**ALAMEDA COUNTY COMMUNITY DEVELOPMENT AGENCY
PLANNING DEPARTMENT**

2ND ADDENDUM TO PRIOR STAFF REPORTS

APPLICATION: CONDITIONAL USE PERMIT, PLN2014-00056

PROPOSAL: To approve the Summit Wind Repower Project, to redevelop an existing wind farm through replacement of up to 569 older wind turbines with up to 31 new approximately 2.1 megawatt (MW) turbines, resulting in a maximum capacity of roughly 54 MW, and adding new technology and infrastructure.

FIGURE 1
PROPOSED TURBINE 11
IN RELATION TO
NEAREST RESIDENCE

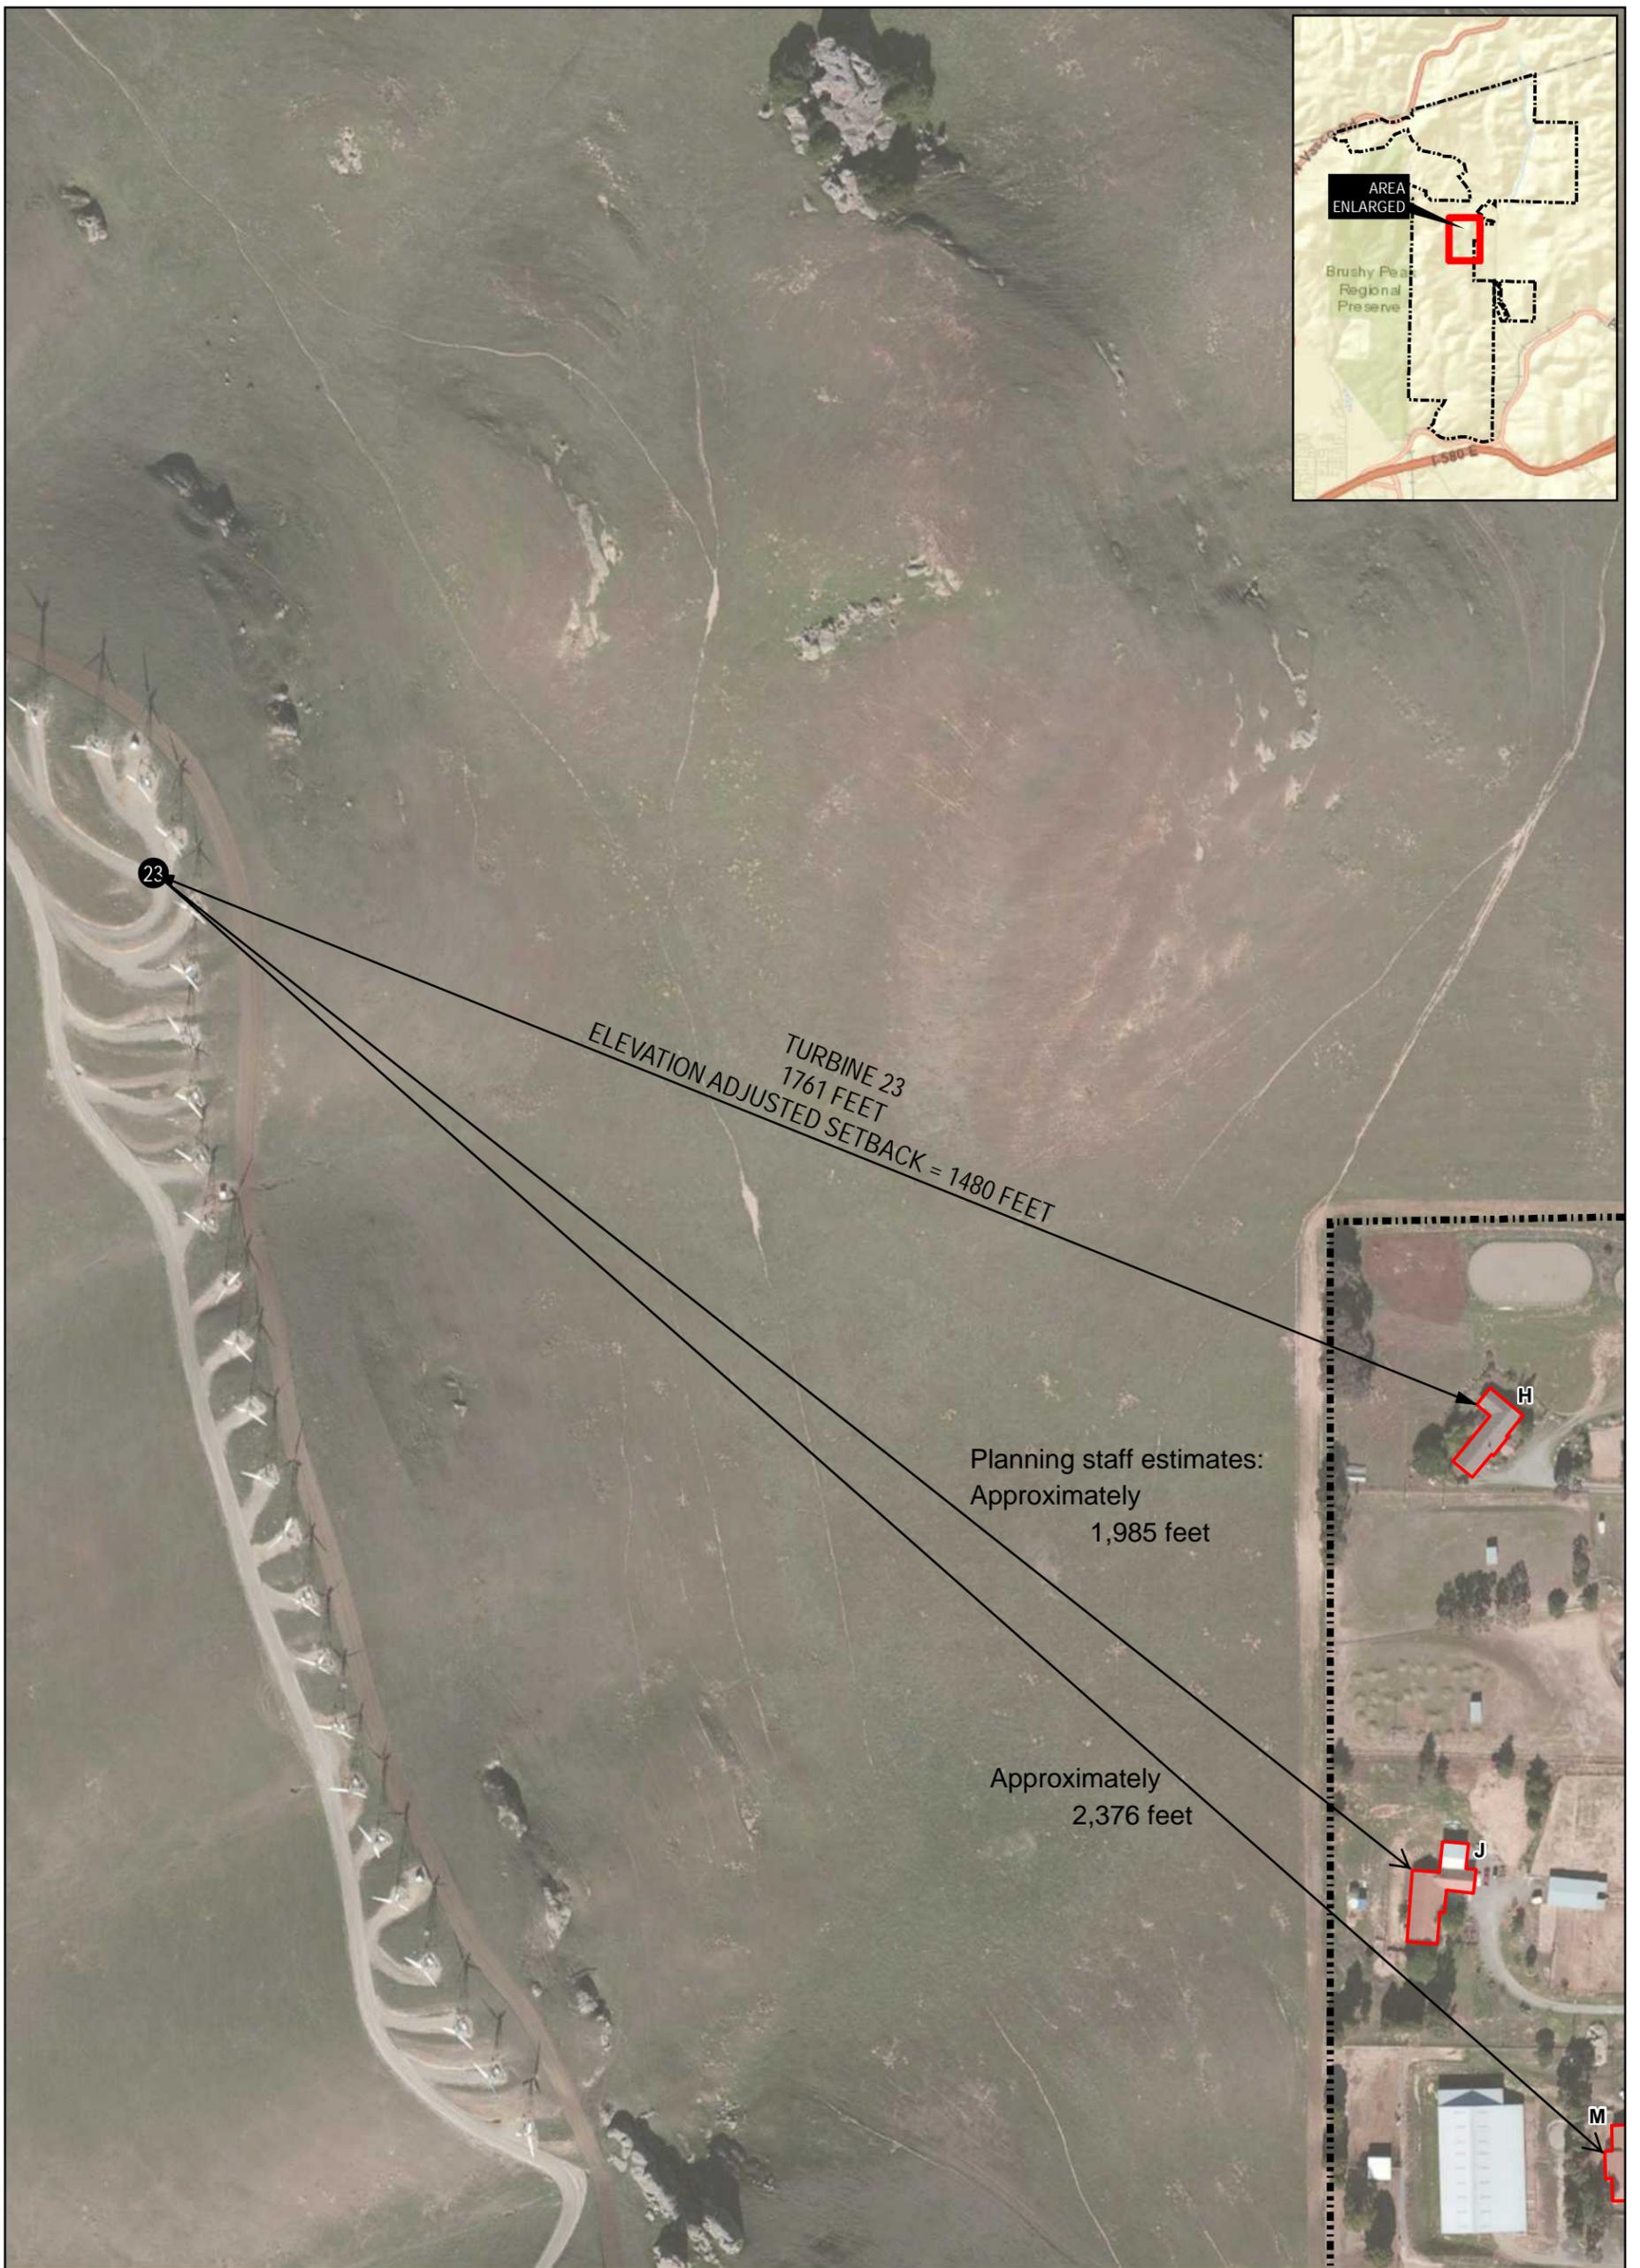
As detailed in **Table 3** below, residences located in proximity to the proposed wind turbine numbers 11, 24, 25 and 30 would fall outside of the alternative minimum setbacks, but would fall within adopted County setback standards when topographic elevations are taken into account. Two of these turbines, 11 and 25, would affect properties whose owners have agreed to provide the necessary setback waivers. The elevation adjusted setback associated with turbine 24 (at current preliminary siting tolerances) and residence/receptor H falls within the current preliminary siting and elevation adjusted setback, but is within seven feet of being outside of the required setback. With this distance, final design micro-siting of turbine 24 in relation to residence/receptor H would adjust this distance so as to place the turbine beyond the 1,460-foot County adopted elevation adjusted setback standard.

- Receptor B is 864 feet from turbine 11 (Figure 1)
- Receptor H is 1,453 feet from turbine 24 (Figure 3)
- Receptor J is 1,475 feet from turbine 24 (Figure 3)
- Receptor O is 1,594 feet from turbine 25 (Figure 4)
- Receptor P is 868 feet from turbine 25 (Figure 4)
- Receptor Y is 1,071 feet from turbine 25 (Figure 4)

FIGURE 4
PROPOSED TURBINE 25
IN RELATION TO
NEAREST RESIDENCE

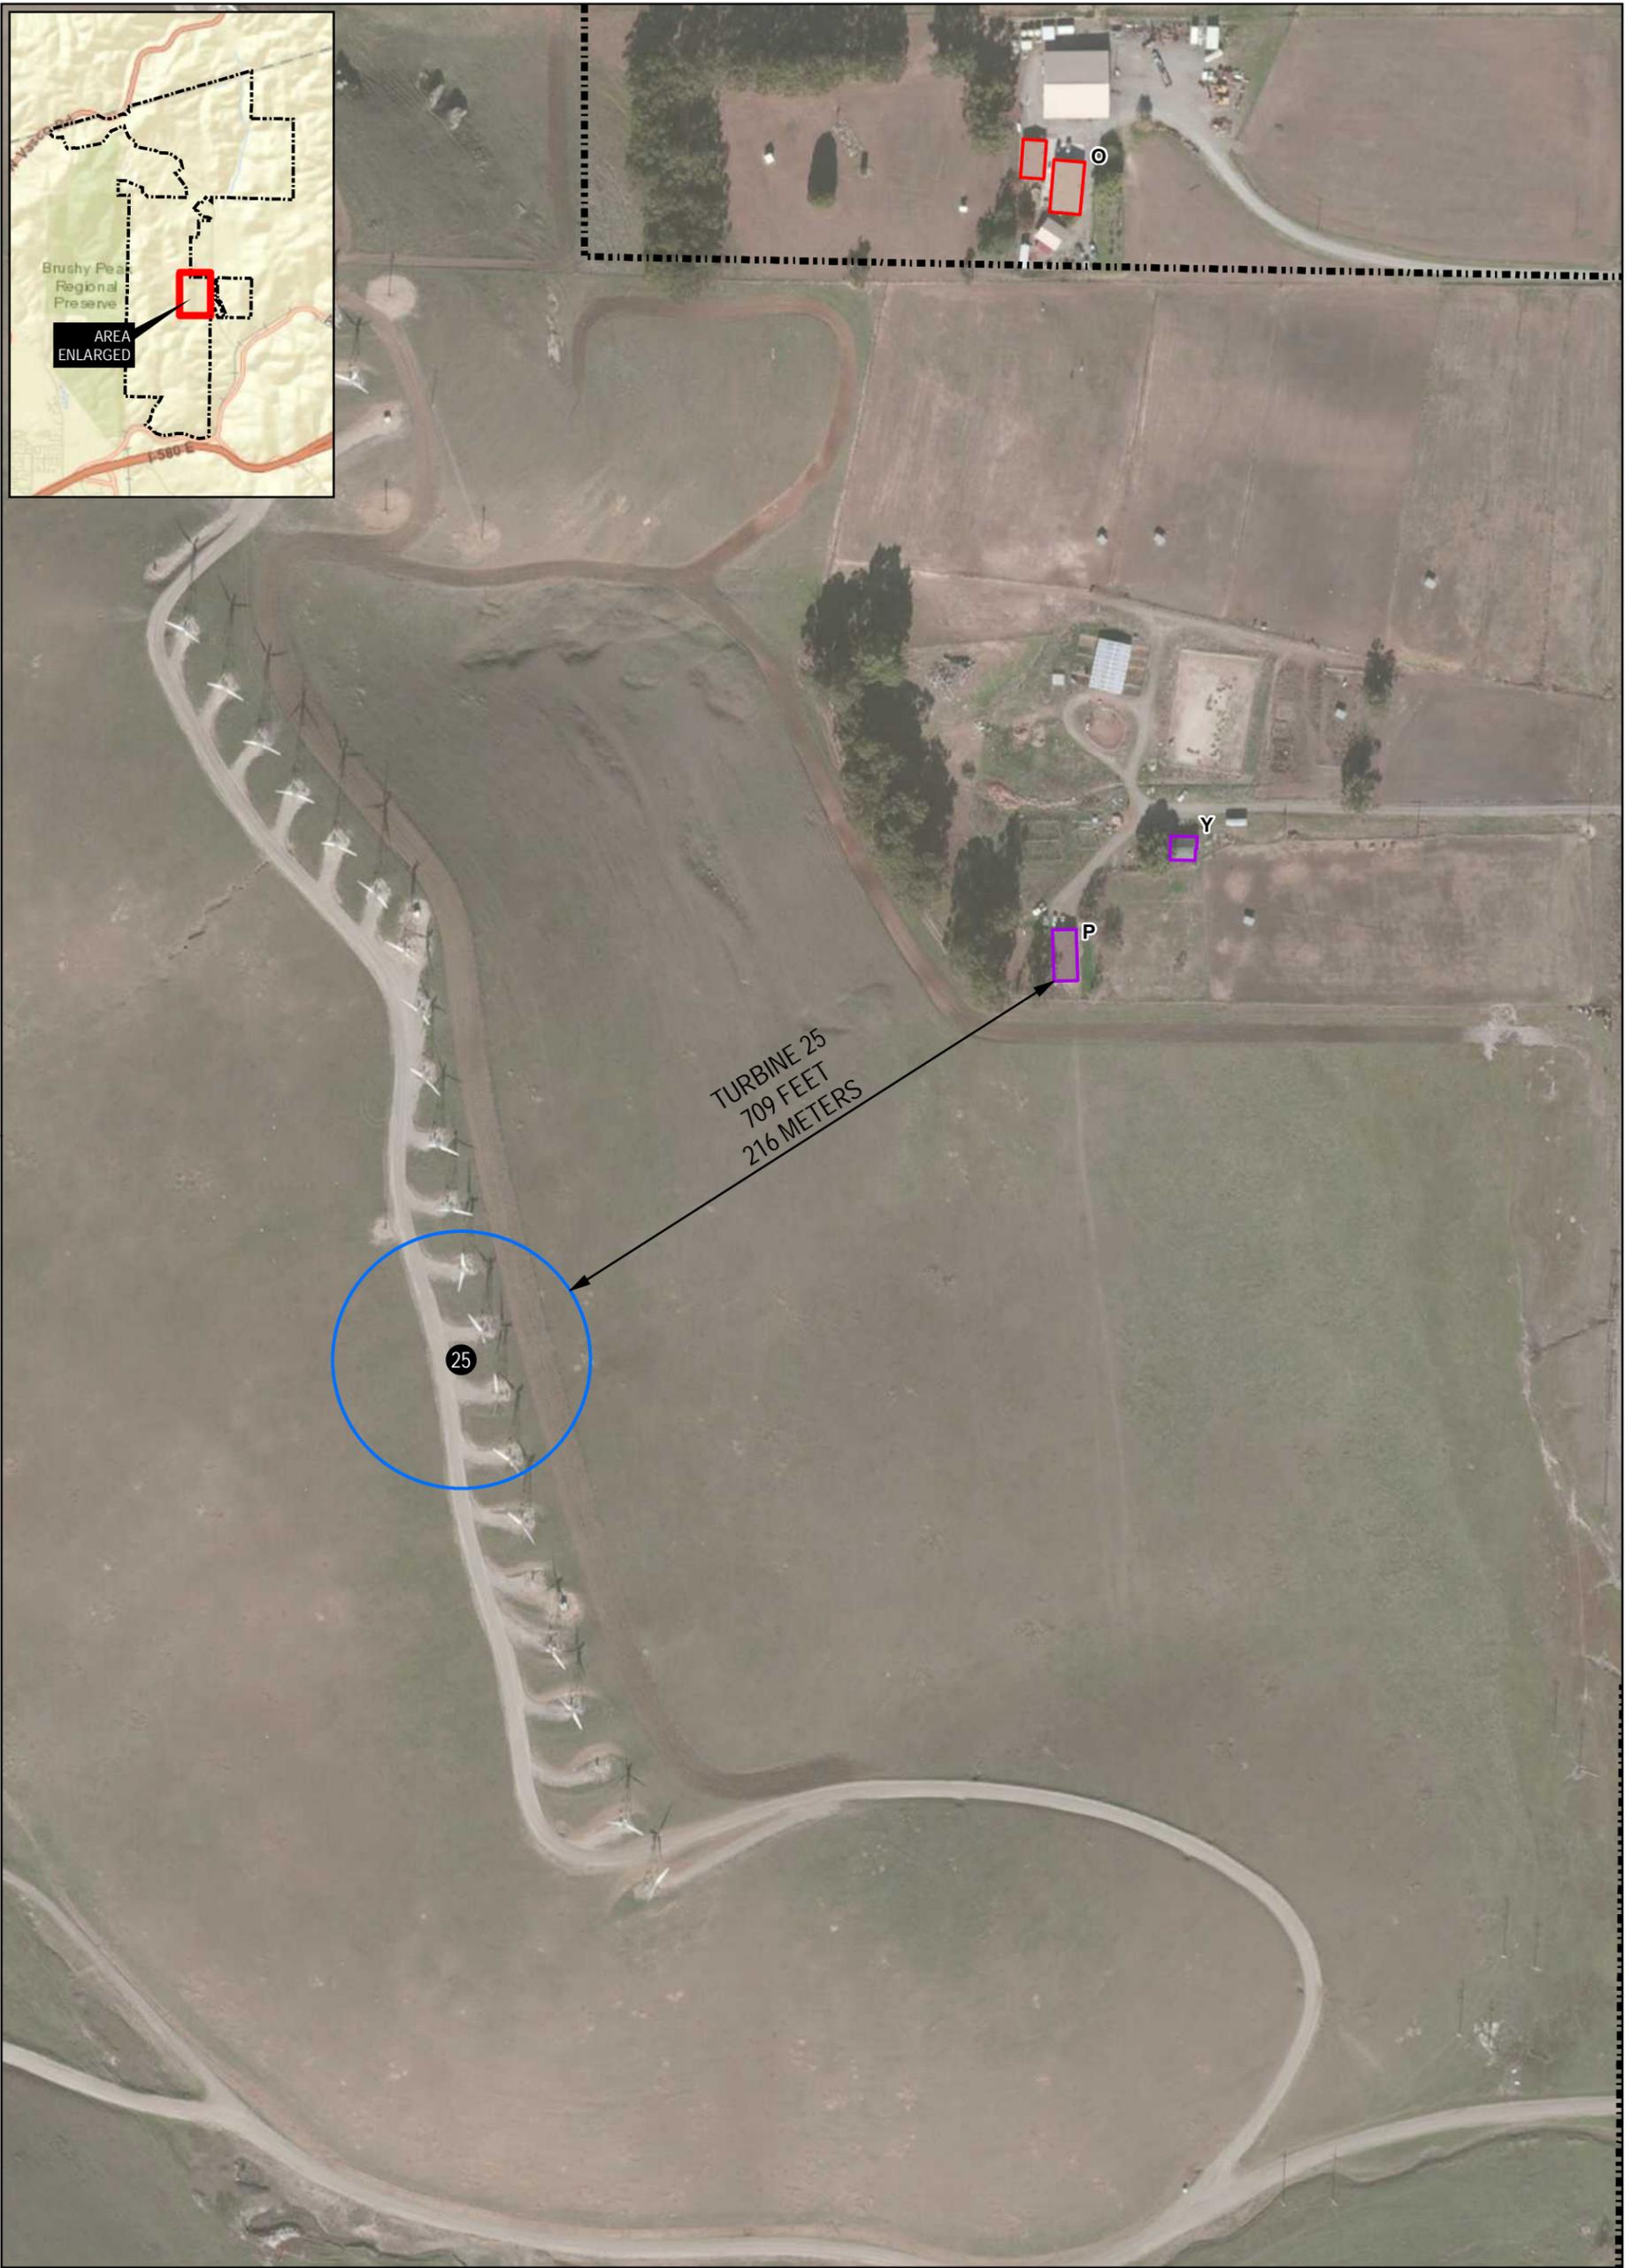
- It is unclear why the distance to a PGE line is used as a standard.
- The house near Turbine 25 is approximately 224 meters from the turbine and sits right at the edge of the shaded circle indicating the blade throw distance.

2. Shadow flicker, page 19: Add Receptor O as being within the 1,640 ft limit (it is 1,594 ft from WT25 per Fig. 4). We note, however, that Receptor O is not exposed to shadow flicker in excess of the thresholds. Also, Receptor L is not mentioned (and it exceeds 30 min/day)—is it beyond the 1,640 ft limit? Include Receptor L in the appropriate context (either within or outside the 1,640 ft limit).
